Office Action Summary	Application No. 10/510,432	Applicant(s) KIMURA ET AL.	
	Examiner Debra Wolfe	Art Unit 3725

DETAILED ACTION

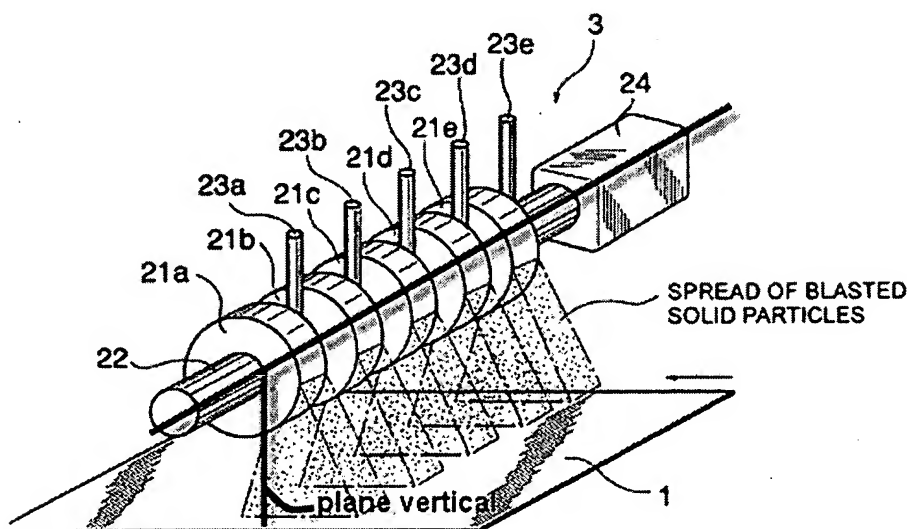
The drawings are objected to under 37 CFR 1.83(a). The drawings must show every feature of the invention specified in the claims. Therefore, a reference to "the plane vertical to the rotation axis" must be shown or the feature(s) canceled from the claim(s). No new matter should be entered.

Claims 1-9 are rejected under 35 U.S.C. 112, first paragraph, as failing to comply with the enablement requirement. The claim(s) contains subject matter which was not described in the specification in such a way as to enable one skilled in the art to which it pertains, or with which it is most nearly connected, to make and/or use the invention. The limitation of claim 1 requires the line of intersection between the plane vertical to the rotation axis and the plane of the metallic sheet to become parallel to or 45° or less angle to the direction of travel of the metallic sheet, however the terminology "the plane vertical" is unclear to enable one of ordinary skill in the art to make or use the invention. Furthermore, the specification and drawings fail to provide reference lines to define what applicant claims as "the plane vertical".

Claims 1-9 are rejected under 35 U.S.C. 112, second paragraph, as being indefinite for failing to particularly point out and distinctly claim the subject matter which applicant regards as the invention. The limitation of claim 1 referring to the plane vertical to the rotation axis is unclear therefore rendering the claim indefinite. Applicant fails to disclose in the specification and drawings what is the plane vertical. It appears that applicant is trying to claim the orientation of the blast range with respect to the direction of travel of the metallic plate by defining the orientation of the blasting machine, however as understood by the Examiner the plane vertical to the rotation of axis is unable to be parallel but rather will be perpendicular to the direction of travel of the metallic sheet [See FIG below].
